Document Title: Revised Addendum to the Revised Work Plan for East Ravine Groundwater Investigation, PG&E Topock Compressor Station, Needles, California

Response to Comments on August 27, 2010 Submittal

DOCUMENT REVIEW AND COMMENT RESOLUTION SHEET

Document Title	Addendum to the Revised Work Plan for East Ravine GW Investigation	**Document Date**	9/27/2010
		Originator, Organization and Phone Number	PG&E/CH2MHILL
Reviewer, Organization, and Phone Number	DOI – Contact /Pam Innis Project Manager, (303) 445-2502	**Review Criteria**	Technical and CERCLA Compliance

FIGURE 2
SITE PLAN FOR EAST RAVINE AND COMPRESSOR STATION GROUNDWATER INVESTIGATION

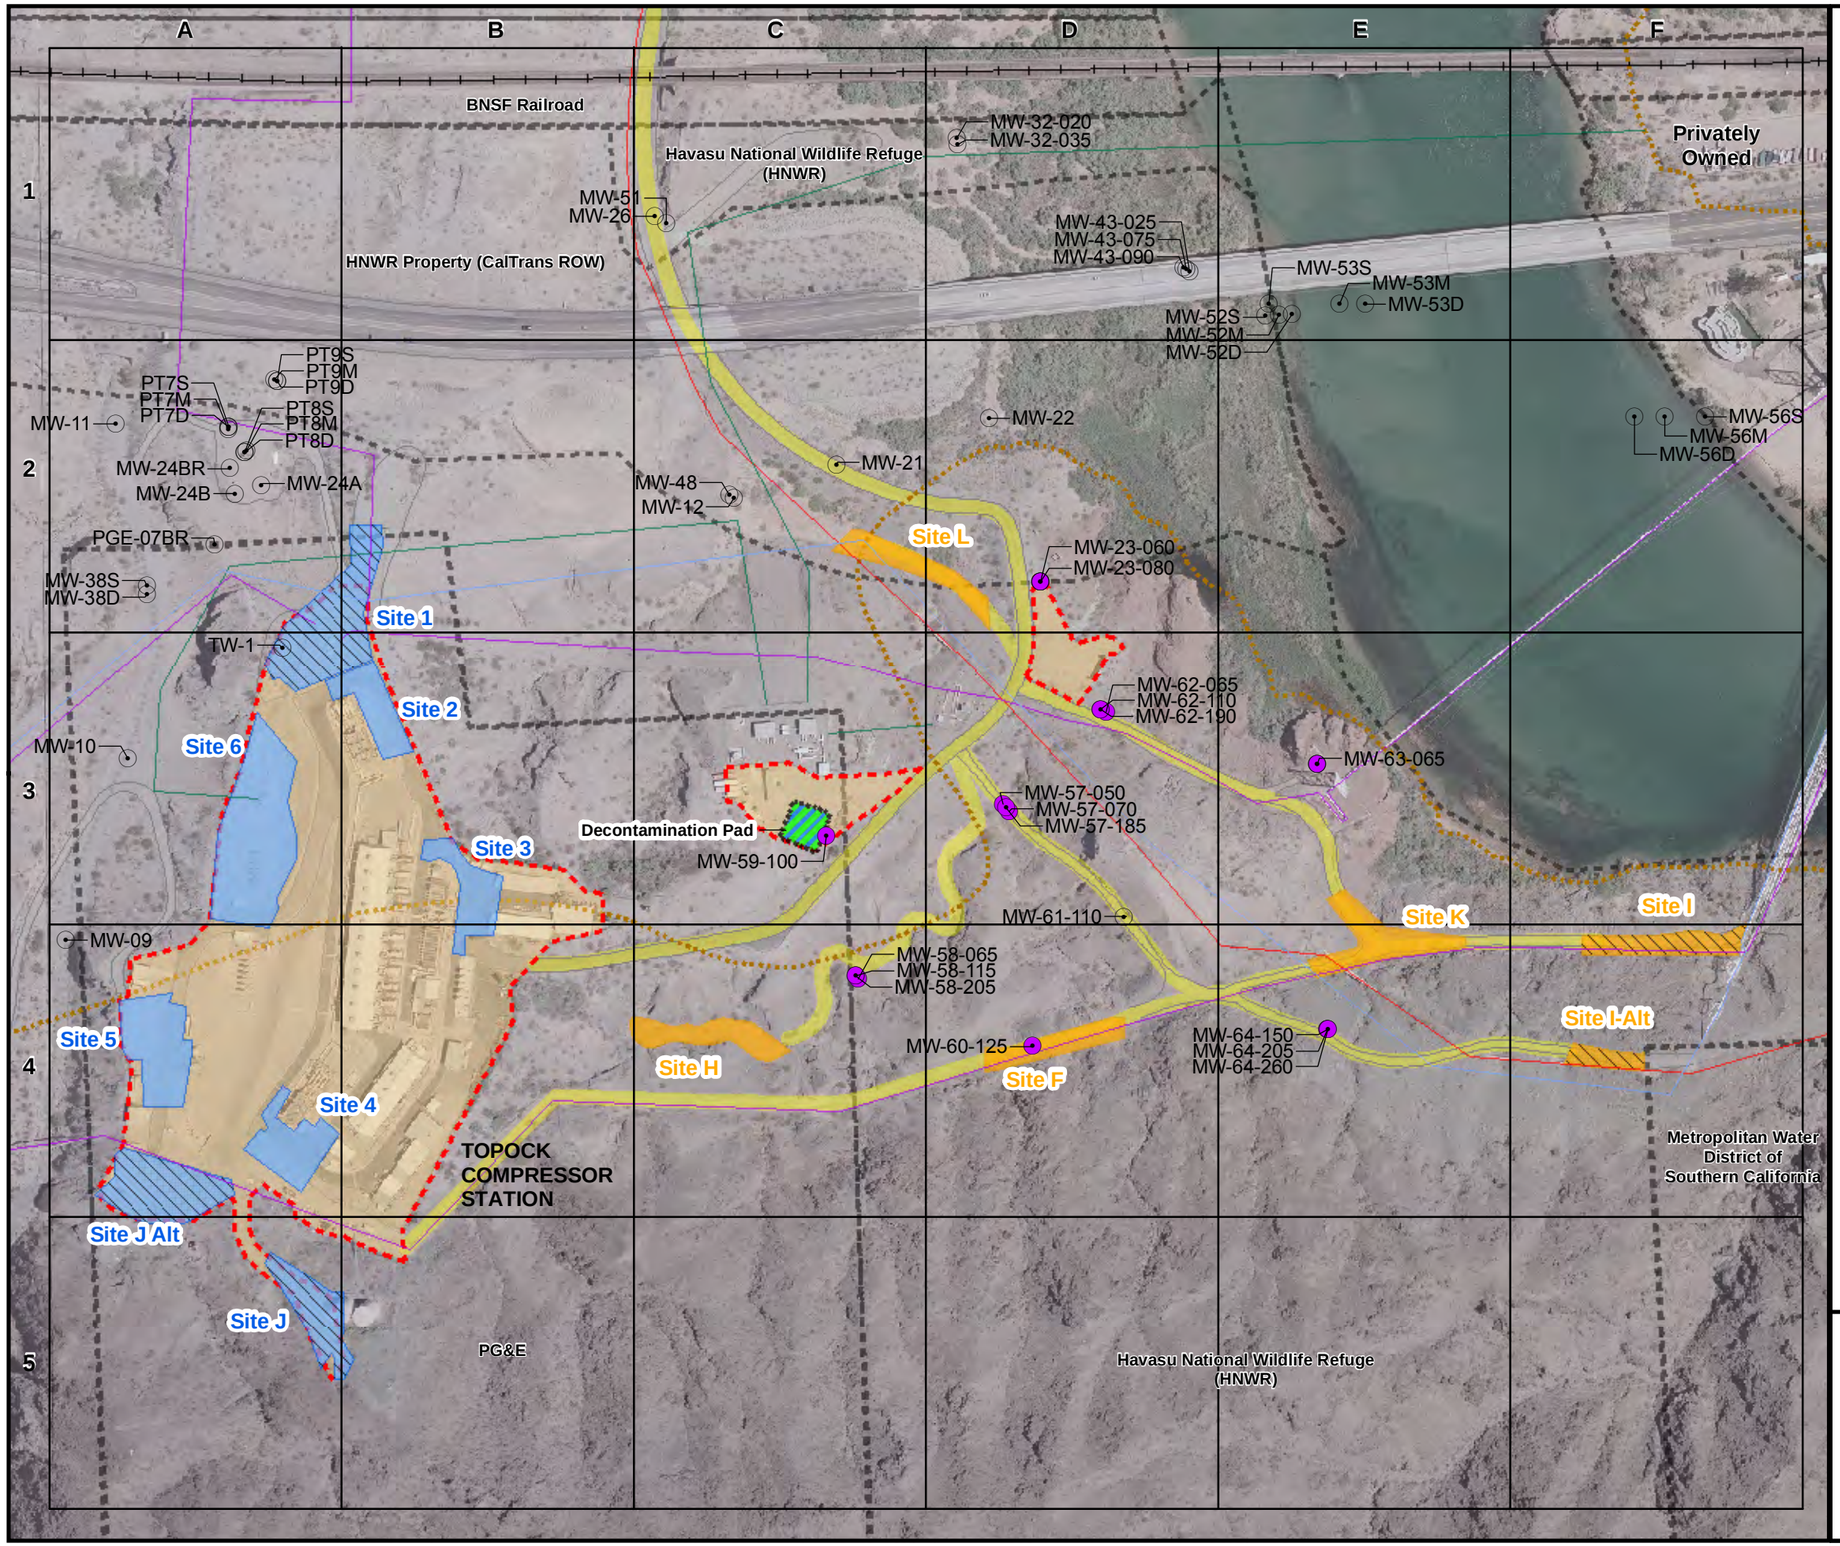
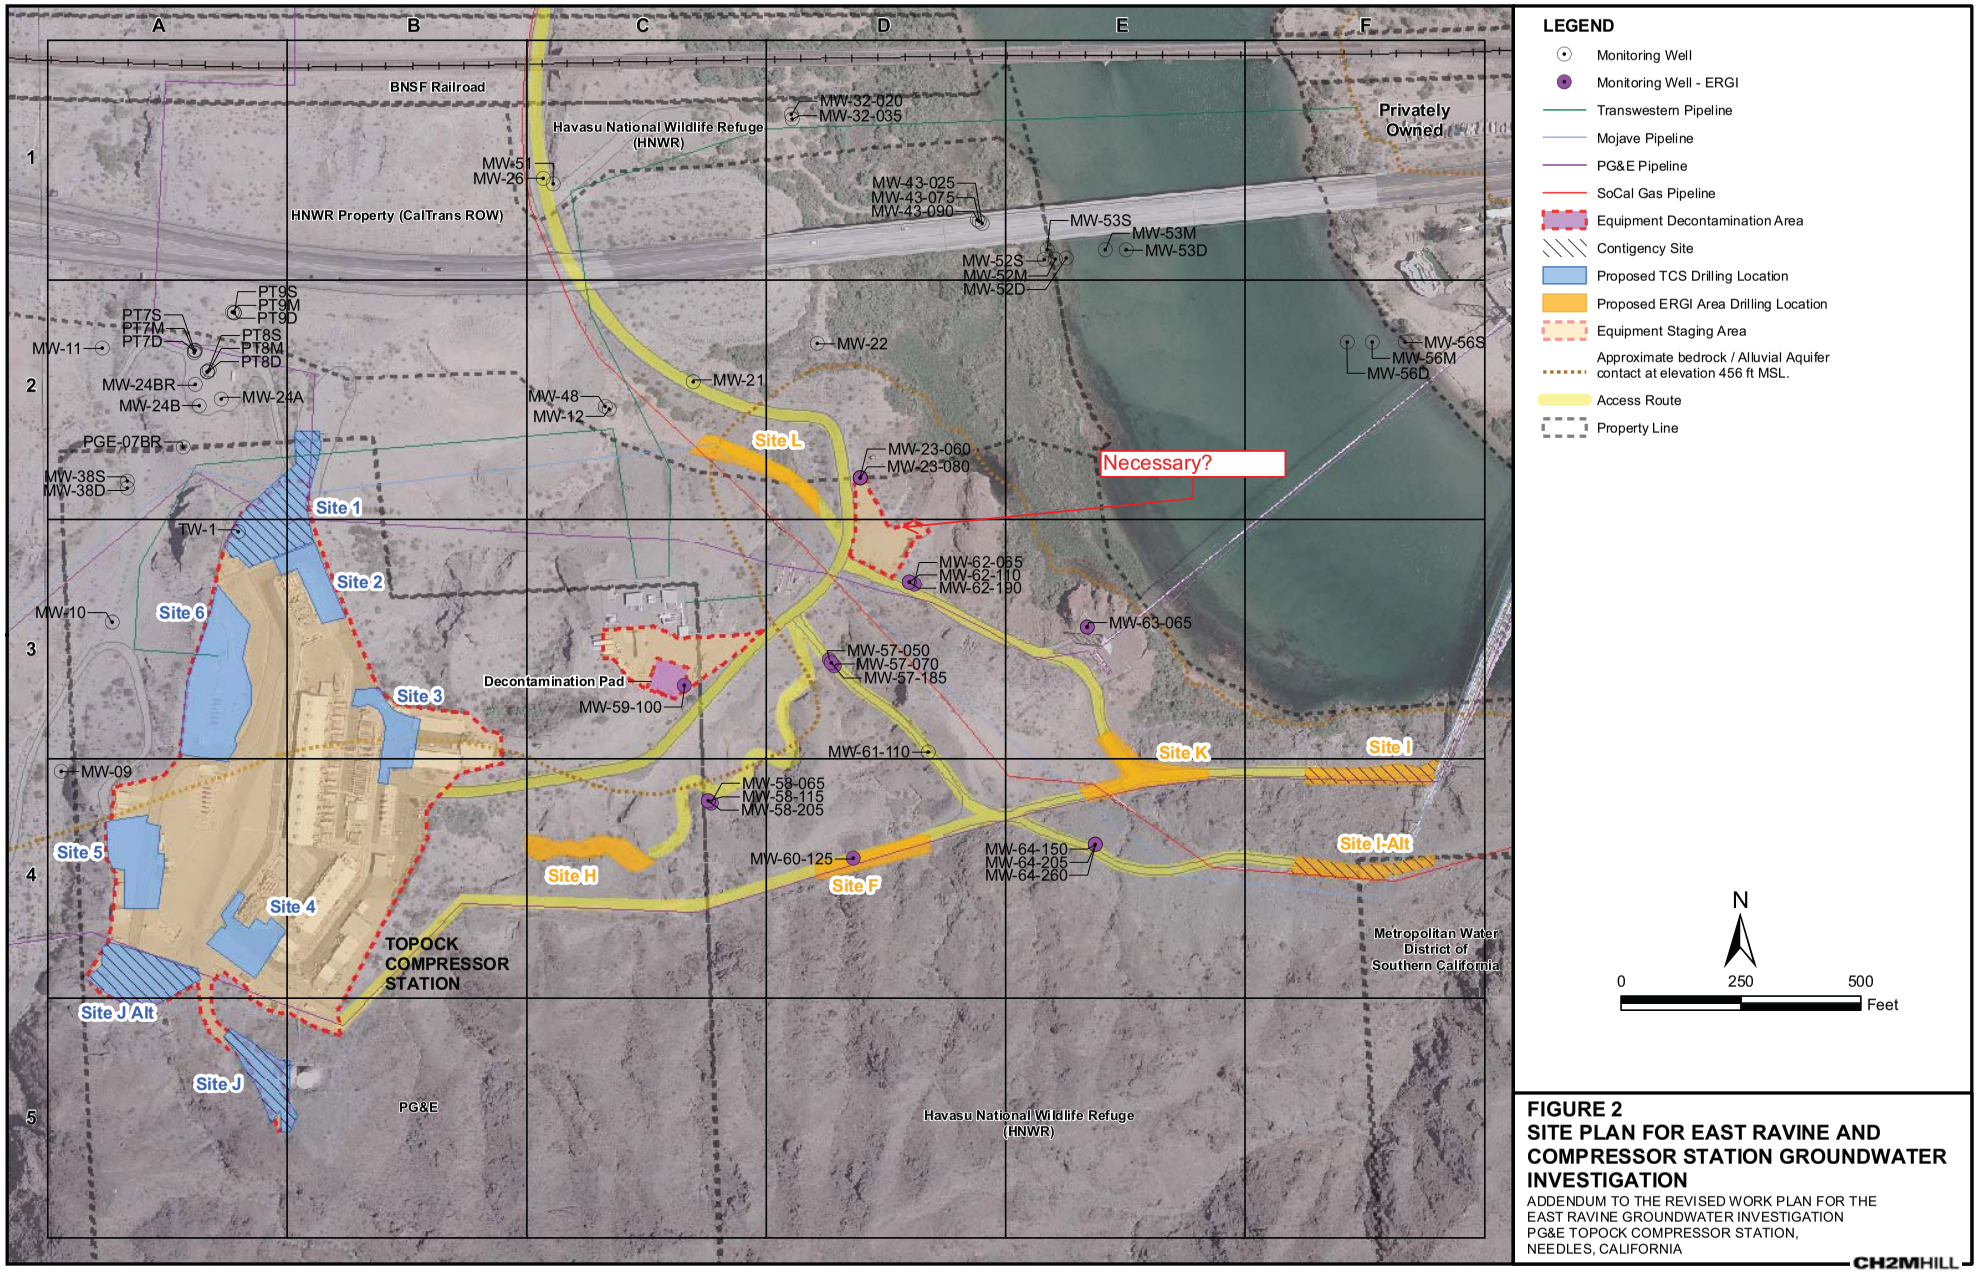
Section 2.7 (Site Restoration Activities) contains errors, is vague, and provides no mitigation or restoration standards. For example, it states that location “I-Alt” is on the Havasu National Wildlife Refuge property; however, Figure 2 shows it located, at least in part, on Metropolitan Water District (MWD) property. Has MWD signed off on this use of their land? This section also delays restoration discussions and requirements until "after well installation." Criteria for site restoration must be developed, reviewed, and approved as part of the work plan. The Tribe expects to participate in these discussions during work plan preparation and prior to its approval.

The Tribe has also questioned why such large areas are called out for each of the primary sites and contingency sites as indicated on Figure 2. It would seem that the actual drilling and construction activities would only disturb much smaller areas. While these large delineations were possibly intended to represent general locations areas within which much smaller disturbances would occur, this is not explained in the workplan.

FIGURE 3
SCHEMATIC OF
NESTED WELL CONSTRUCTION
REVISED ADDENDUM TO THE REVISED WORK PLAN
FOR EAST RAVINE GROUNDWATER INVESTIGATION
PG&E TOPOCK COMPRESSOR STATION
NEEDLES, CALIFORNIA

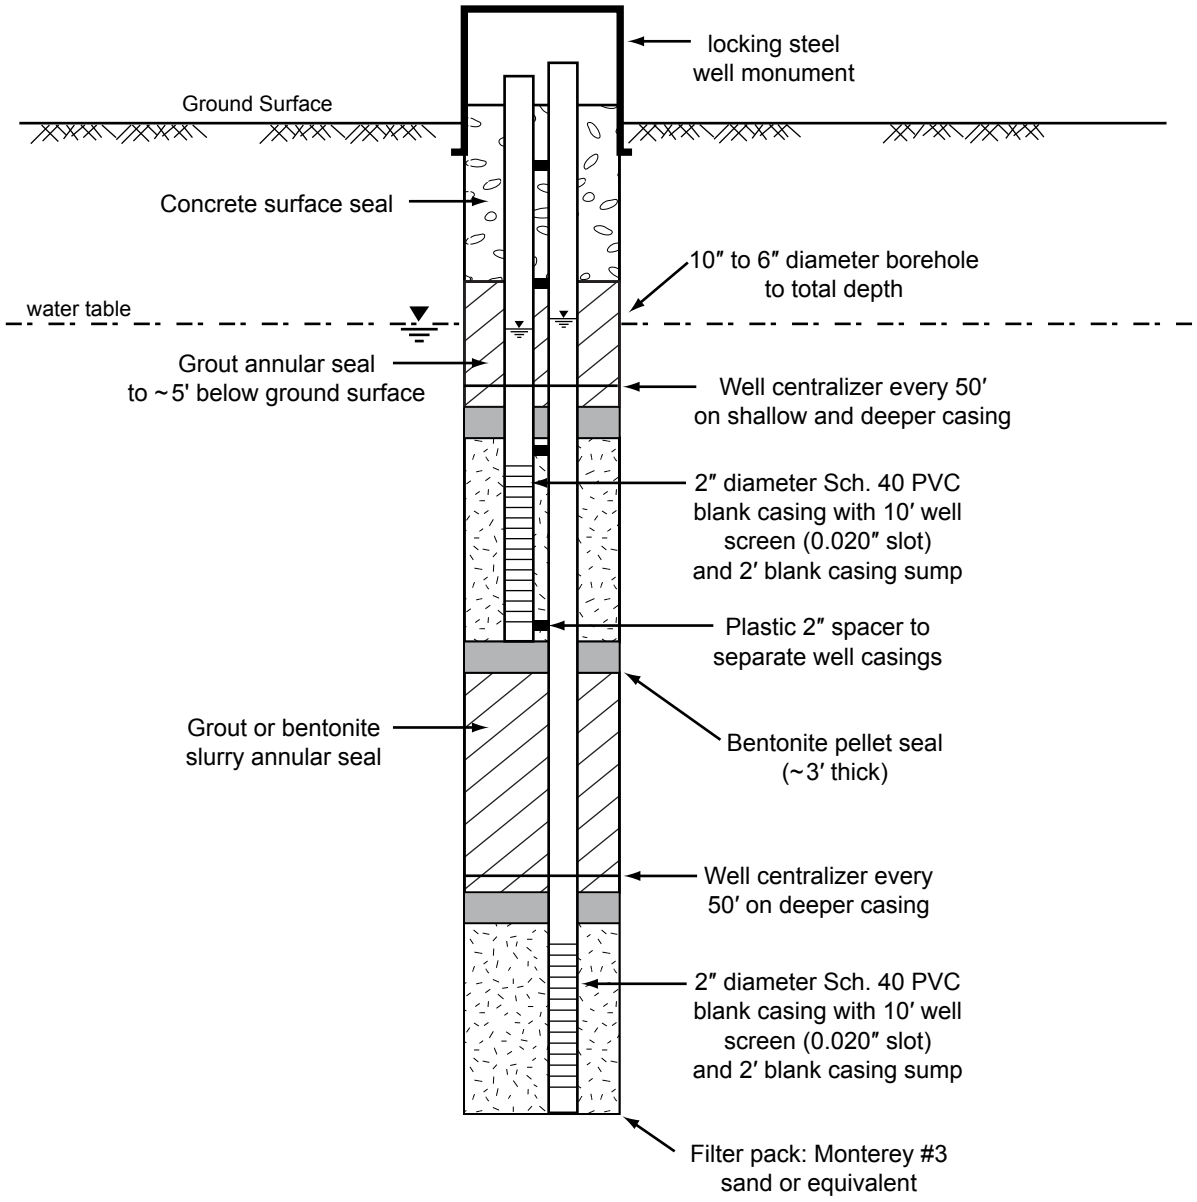
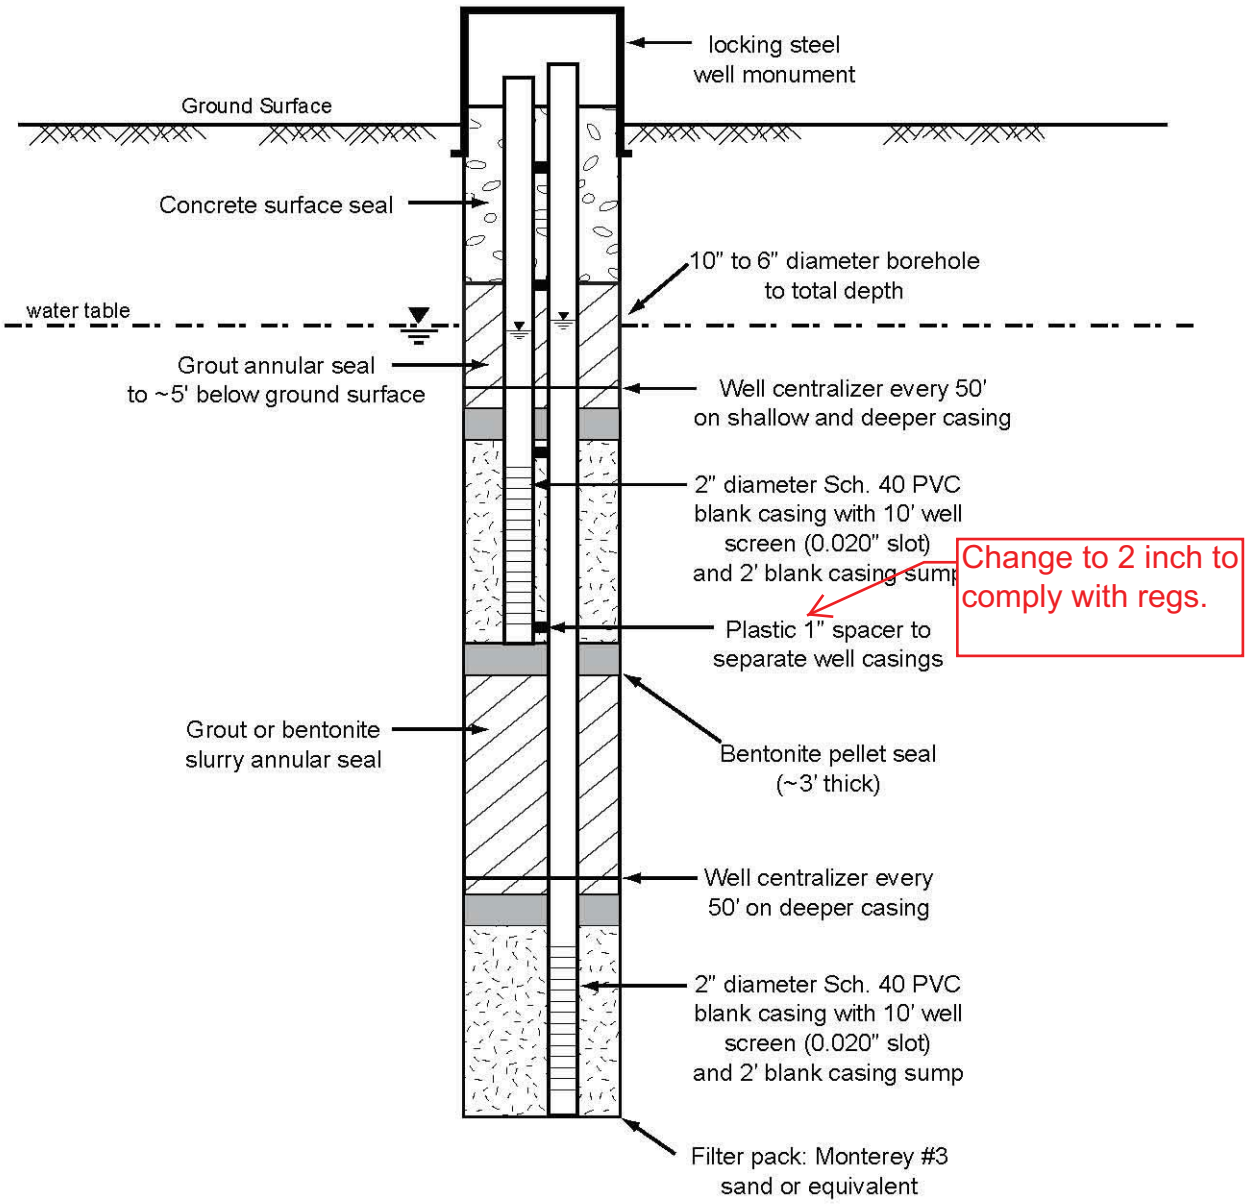
Source	Comment Number	Section / Topic	Comment	Responder	Response to Comment
DTSC Addendum redline	DTSC 8	4.2.4, Conservation Measures	Edit text to resolve type-o.	PG&E	Concur. Text has been revised to read as follows: “Construction activity at these sites may be conducted outside of the bird nesting season to minimize impacts to potentially sensitive riparian habitat.”
DTSC Addendum redline	DTSC 9	Figure 1	Are wells PGE-1 and PGE-2 accurately located on the map?	PG&E	The subject wells were not accurately located on Figure 1. Figure 1 has been revised to show the accurate well locations. The relocation of these wells does not require alteration of the bedrock elevation contours also shown on this figure.
DTSC Addendum redline	DTSC 10	Figure 2	Is the equipment staging area near the Route 66 sign necessary?	PG&E	See response to comment DTSC 6.
DTSC Addendum redline	DTSC 11	Figure 3	Change size of plastic spacer between nested well casings from 1-inch to 2-inch to comply with regulations.	PG&E	Figure 3 has been revised as specified.
